City of Fairburn
Planning and Zoning Commission

AGENDA

SUBJECT: REZONING 18RZ-005 - South Fulton, LLC

To: Planning and Zoning Commission
From: Tarika Peeks, Senior Planner/Zoning Administrator
Date: September 11, 2018 Planning and Zoning Commission Meeting
Agenda Item: **18C-007 - F300 Logistics Center Drive Warehouse** - A request to review the conceptual site plan for a 154,000 square foot warehouse.

Exhibit A

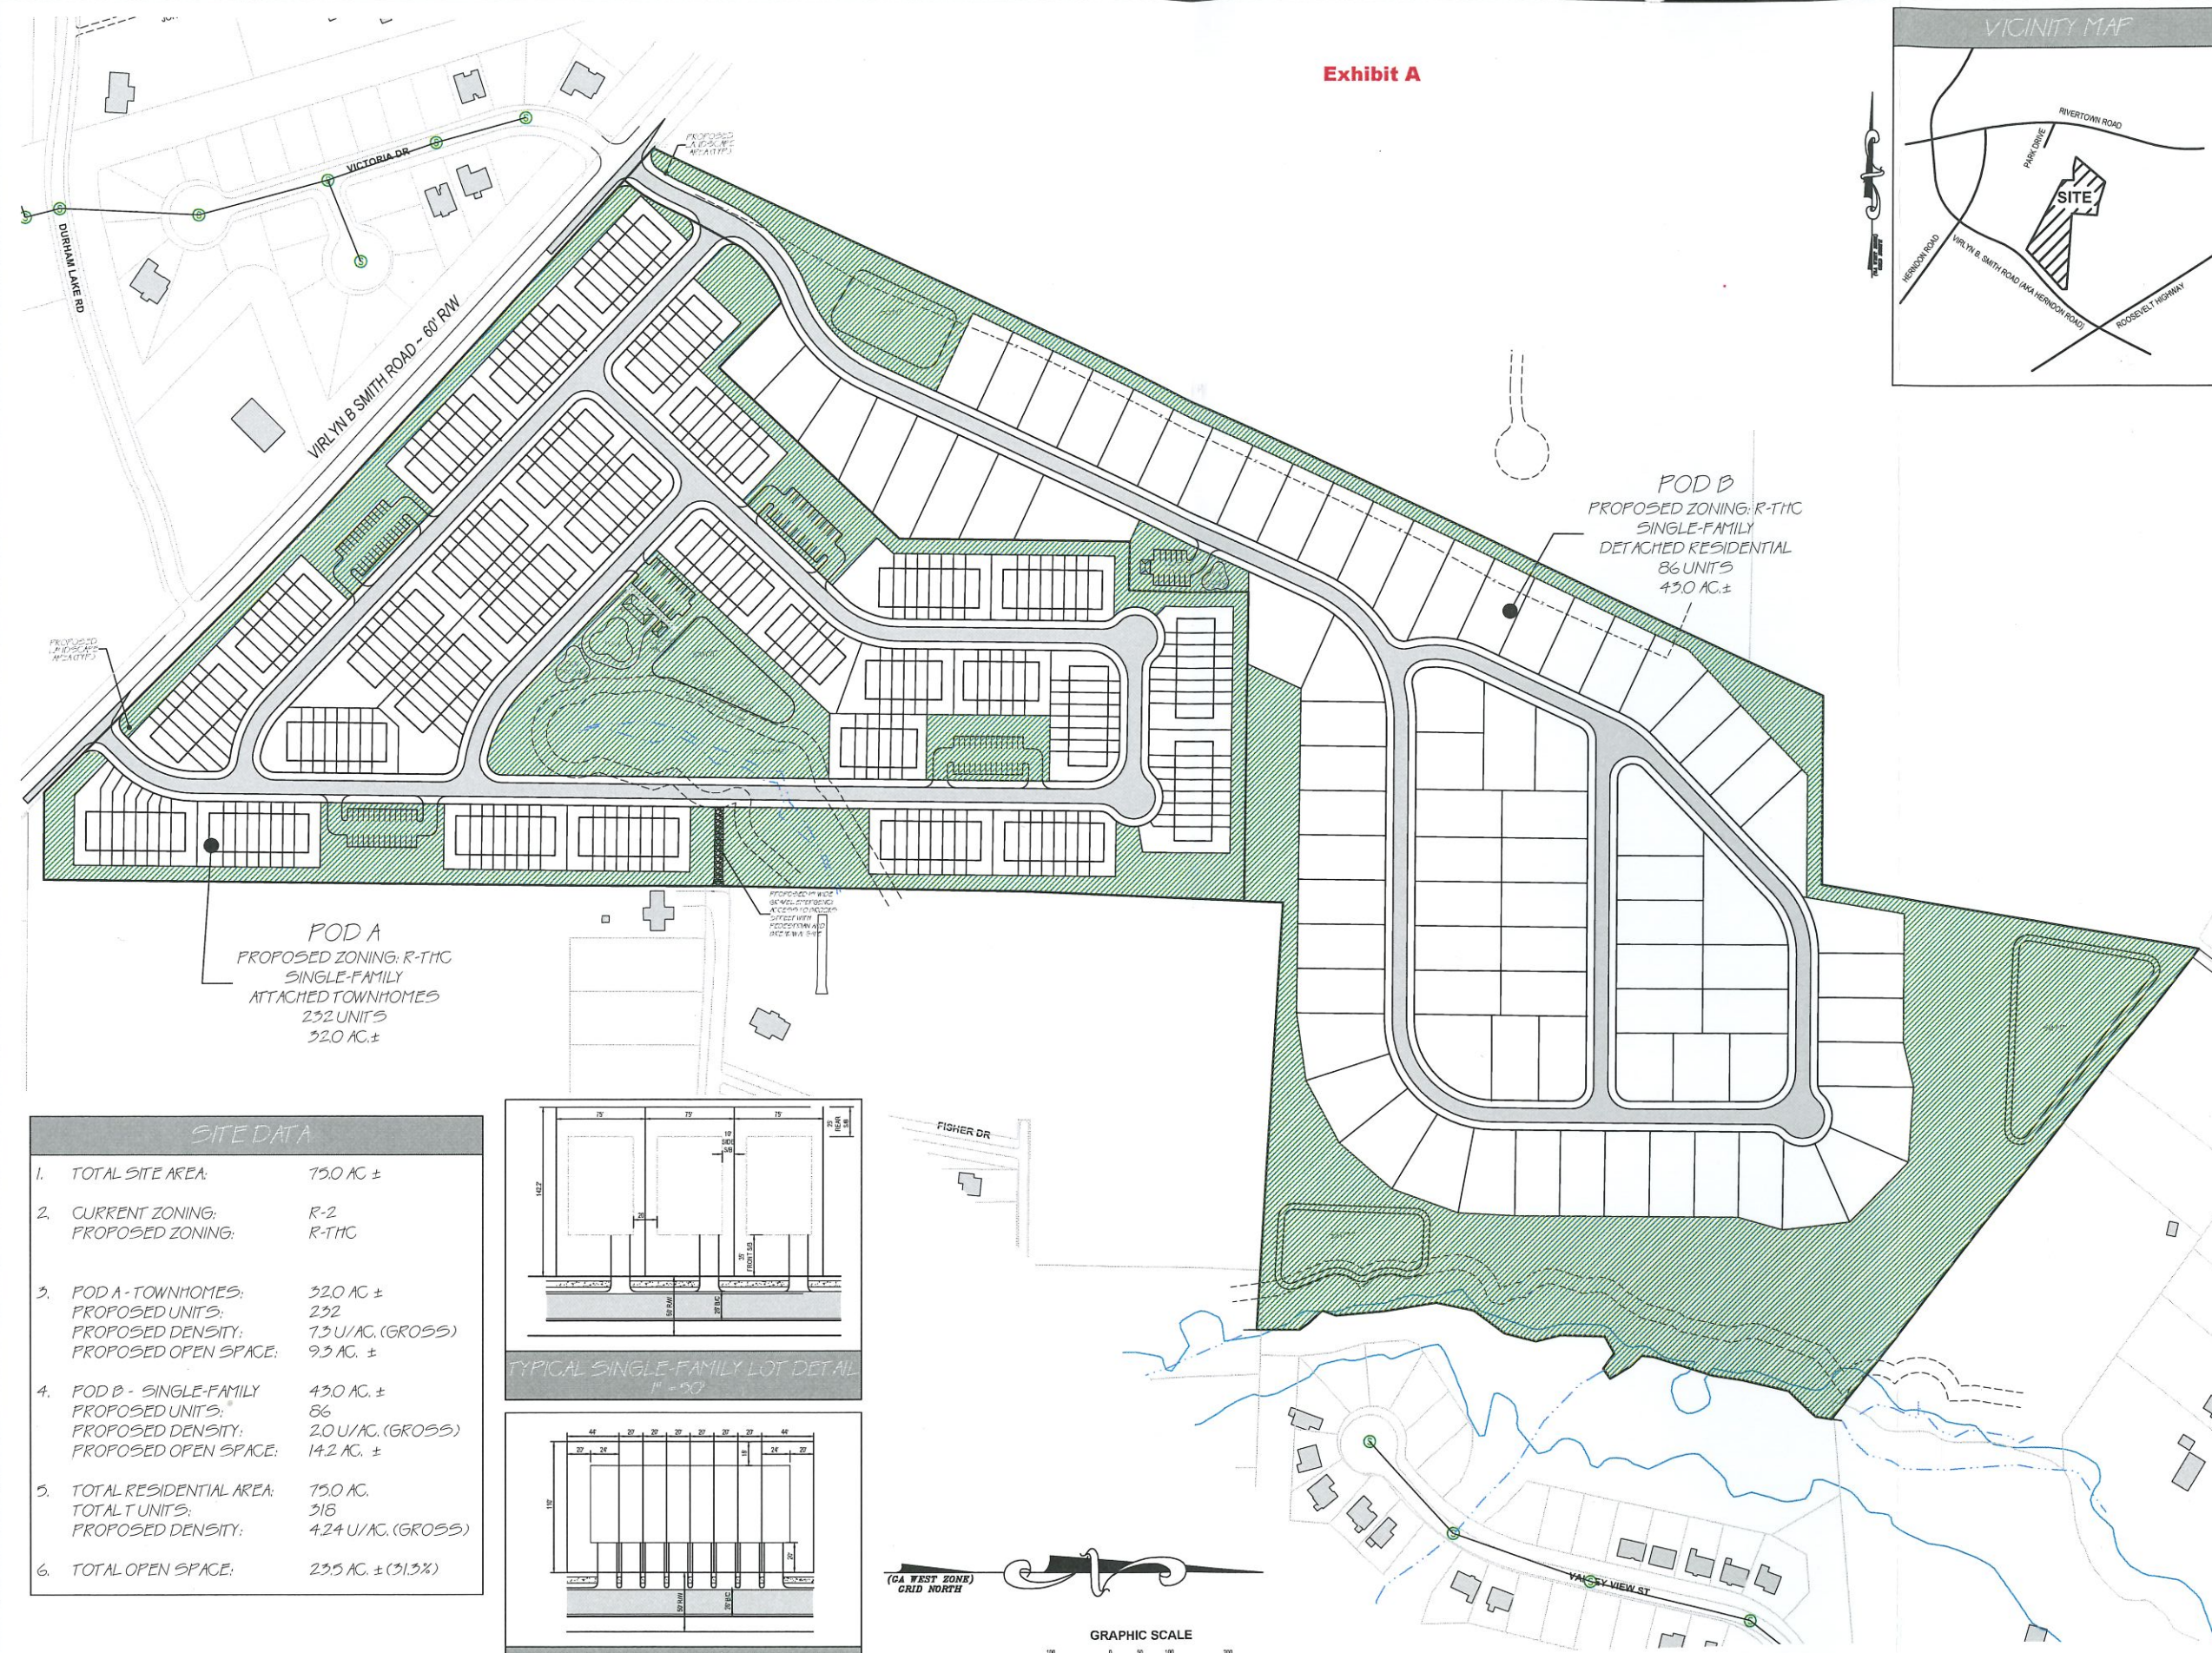
- 1. The property shall be developed in substantial conformity with the Zoning Site Plan prepared by Moore Bass Consulting and submitted with the original rezoning application stamped received July 2, 2018, and attached as Exhibit A. Any determination as to "substantial conformity" shall be made by City staff.
- 2. Property maintenance shall be accomplished through a condominium or townhouse association in which membership shall be mandatory. Such maintenance shall encompass all individual lots and all common areas that are not contained within the boundaries of individual lots. Such association by-laws shall be subject to approval by the City Administrator and shall be recorded with covenants that shall be subject to approval by the City Administrator.

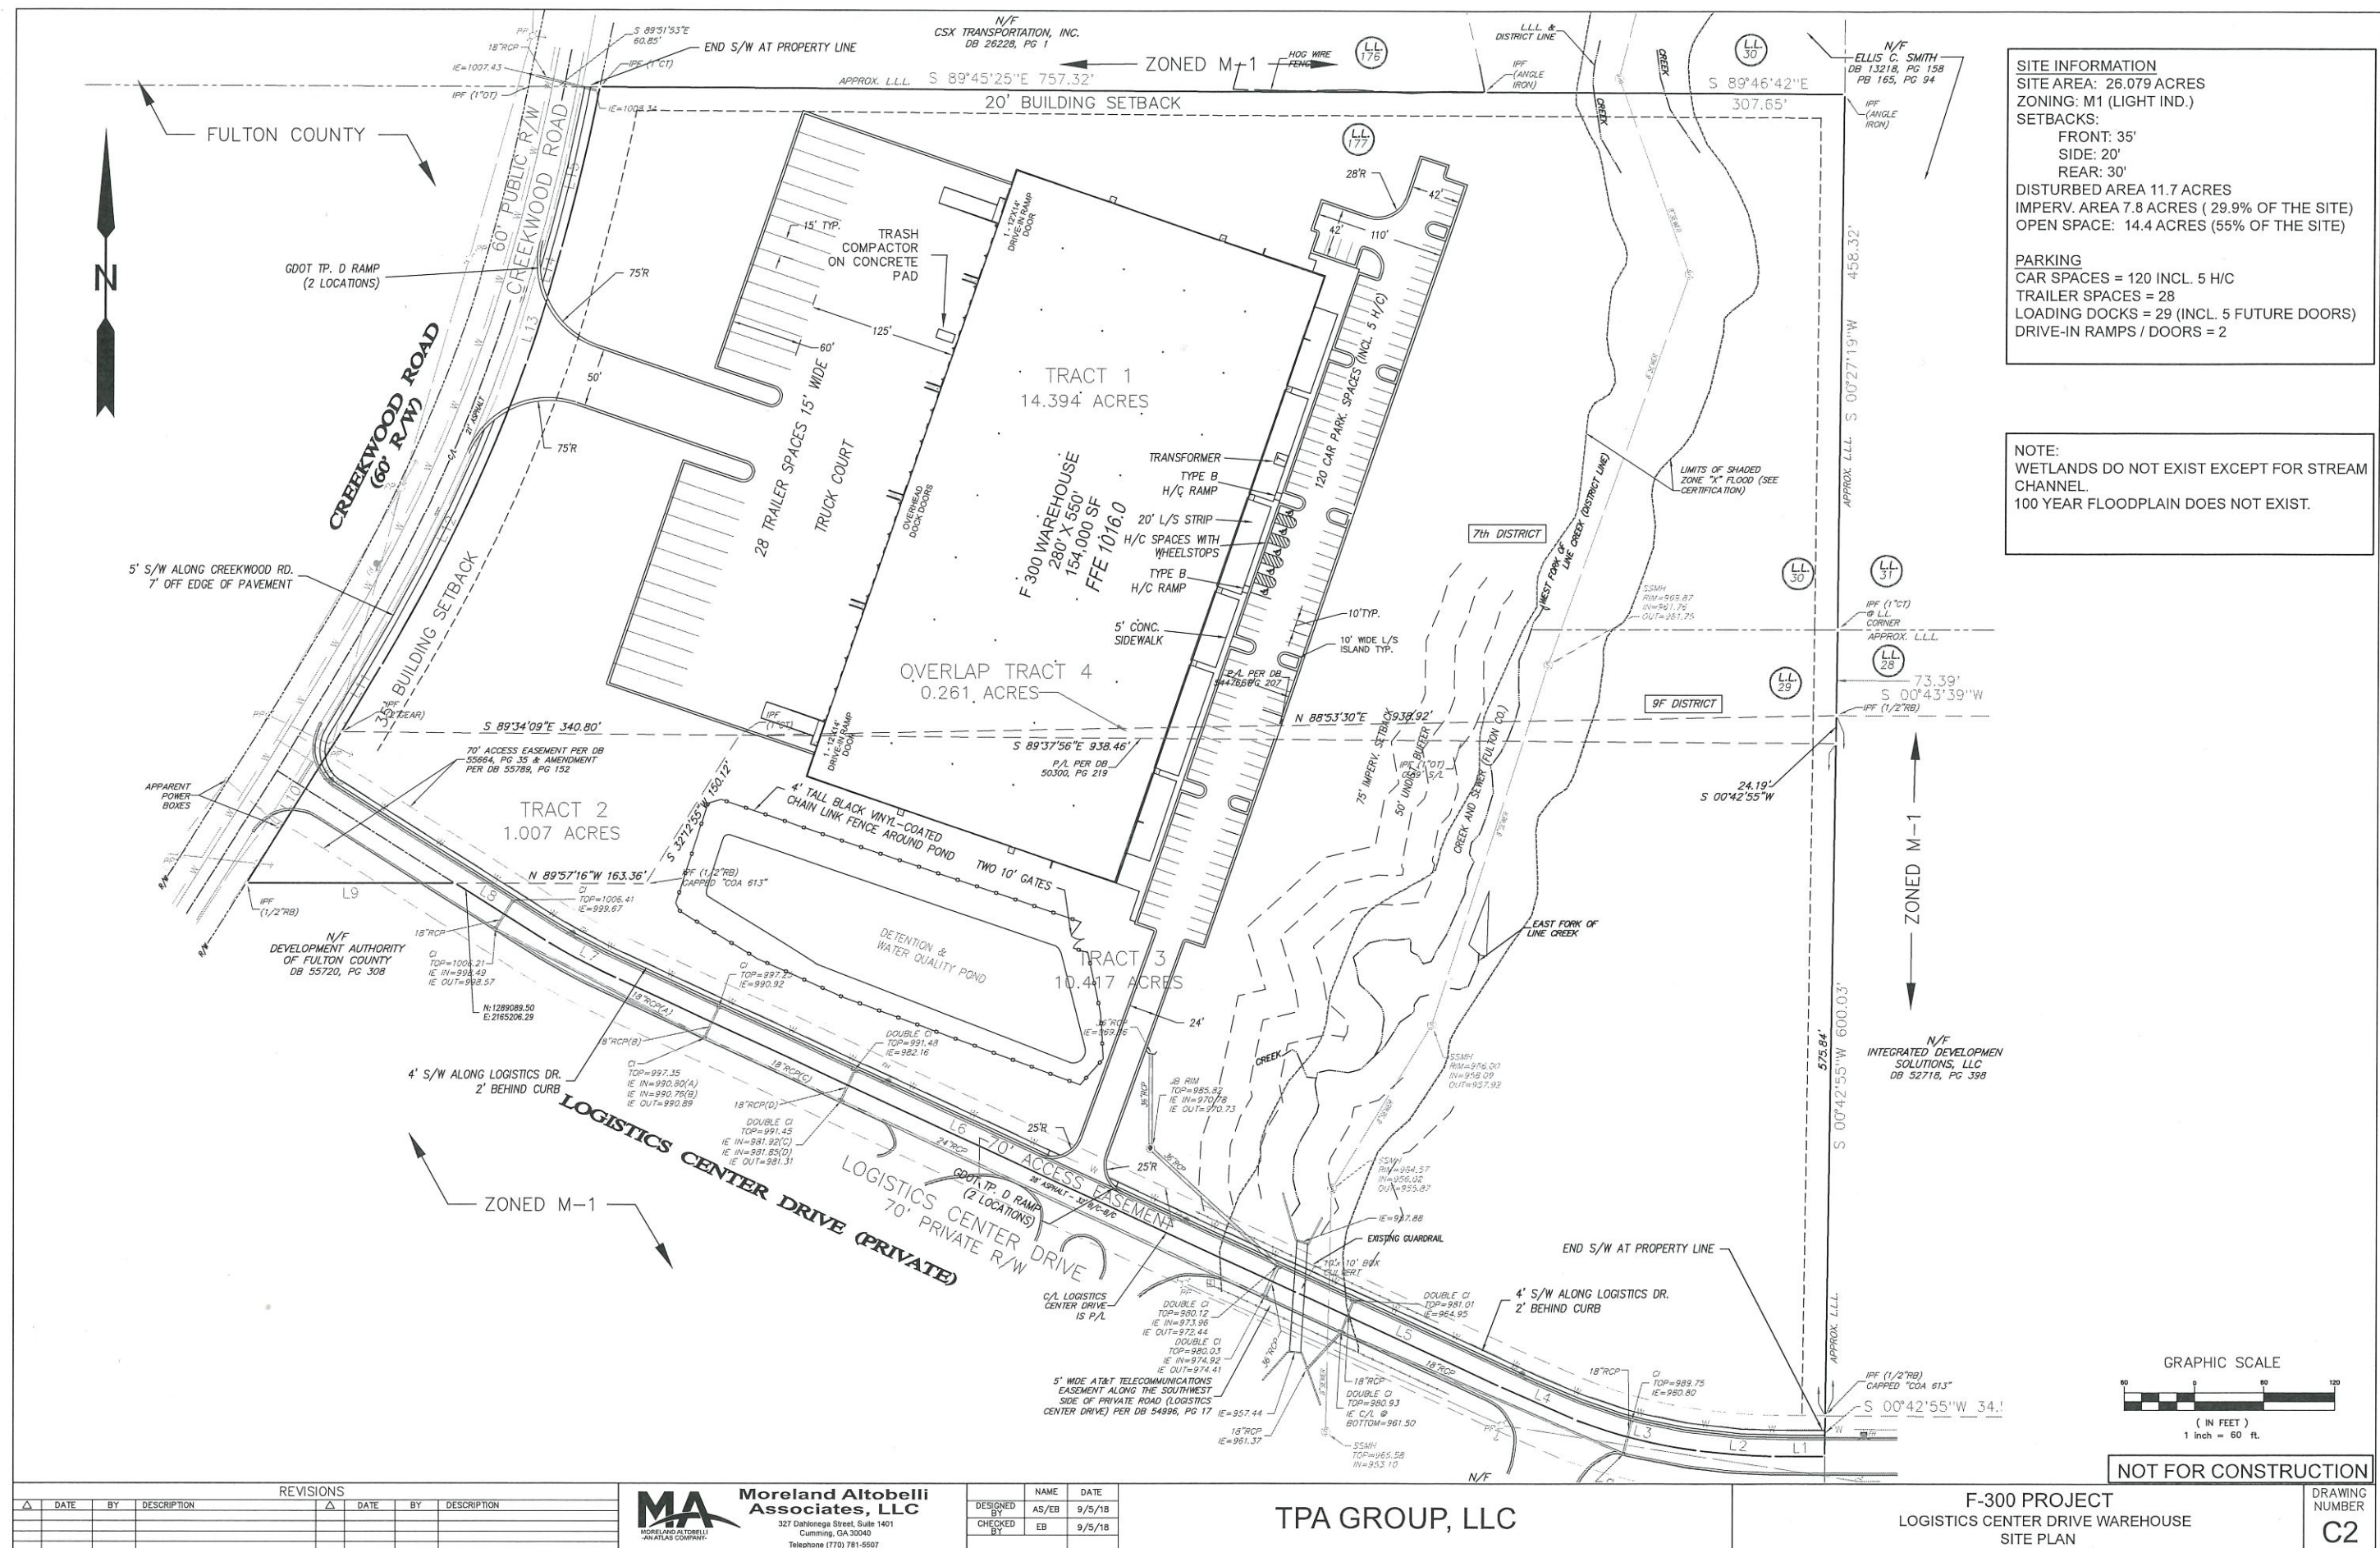
APPROVAL CONDITIONAL of the conceptual site plan to construct a 154,000 square foot warehouse. The staff has reviewed the proposed conceptual site plan and the plan has met the requirements for a conceptual review. Staff has recommended three wo (2) conditions.

The approval of the site plan is conceptual only. The applicant will be required to submit a Land Disturbance Permit and a Building Permit application prior to the start of any construction. Additionally, any significant changes as determined by staff to the approved conceptual plan would warrant a further review by the Planning and Zoning Commission.

1. To the Conceptual Site Plan submitted to the Department of Community Development dated received August 18, 2018. Said site plan is conceptual only and must meet or exceed the requirements of the City's regulations and these conditions prior to the approval of a Land Disturbance Permit. Unless otherwise noted herein, compliance with all conditions shall be in place prior to the issuance of a Certificate of Occupancy.
2. Prior to construction, provide the city with copies of the approved agreements/easements between all involved parties/owners for the driveway; inter parcel access ways, and sidewalks. All plans for the road improvements shall be submitted, reviewed and approved by the City Engineer; and appropriate permits issued prior to construction and authorization.
3. A combination plat shall be approved prior to the issuance of the land disturbance permit.
